PCN-257959  
**Product Change Notice**

**Change Description:**

Introduction of new die source

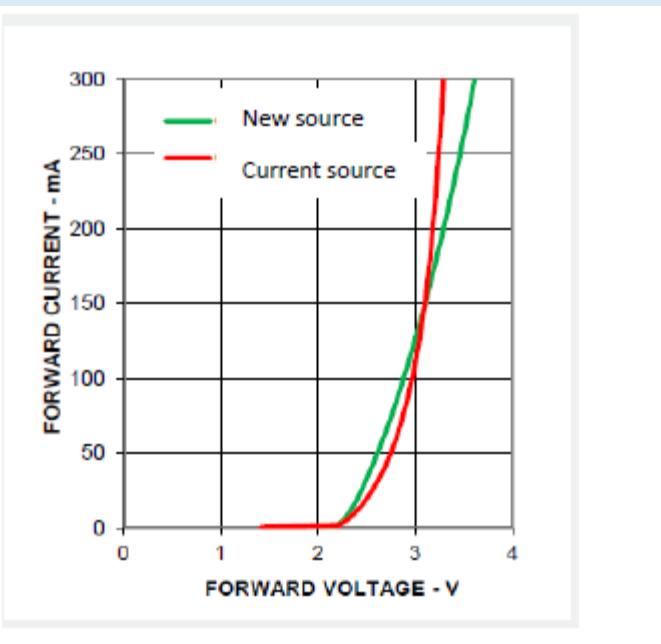
Introduce new die source for above part numbers

Only Vf characteristics of ASMT-QGBE-NGJ0E is slightly different compared to current die source as illustrated below.
